## Report to Council

**To:** Mayor & Members of Council  
**From:** Adele Arbour  
**Date:** April 7, 2026  
**Re:** **Interim Report Regarding Response to Public Meeting Comments  
September 16, 2025  
168 County Road 49 – Official Plan and Zoning By-Law Amendments  
Subdivision File 15T-23001 – Jeffery Homes Limited (2549099 Ontario Inc.)**

**Re: Supplementary Response to Comments Heard at the September 16, 2025  
Public Meeting**

**Re: Technical Response to Public Comments for Part of Lot 19,  
Concession 19, Municipality of Trent Lakes, County of Peterborough  
Cambium Reference: 17986-003**

Figure 1: Borehole Location Plan

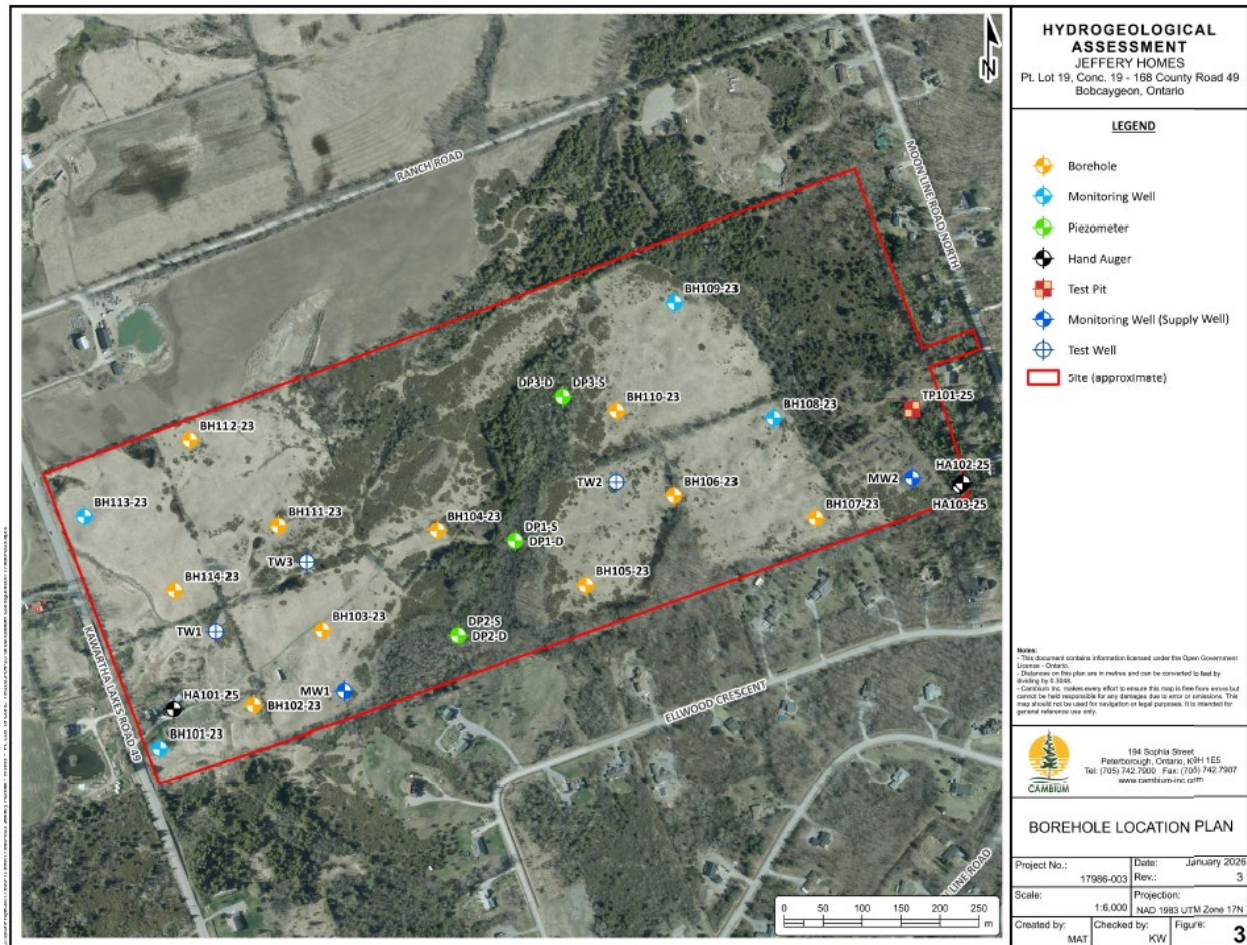
5. The memo states that the existing supply well is denoted as MW2 in Figure 1. Figure 1 illustrates 4 monitoring wells but none are denoted as MW2. Does this paragraph of the report relate to a different figure?

6. The second paragraph of page 6 may have a typo in the reference to an increase in the flow rate to 10 L/min.
7. Figure 1 does not appear to illustrate the location of the new test well denoted as TW3.

One well was tested on each of the wetlands. On the west side of the wetland, the existing well located on proposed Lot 9 (Well ID A104942) was selected to test and denoted as TW1. The existing supply well located on proposed Lot 5 (A104945) was used as a monitoring well and denoted as MW1. On the east side of the wetland, the existing supply well located on the proposed Lot 20 (A104944) was selected to test and denoted as TW2 during the hydraulic pumping test. The existing supply well located on proposed Lot 13 (A104943) was denoted as MW2. The location of the test and monitoring wells are presented on Figure 1.
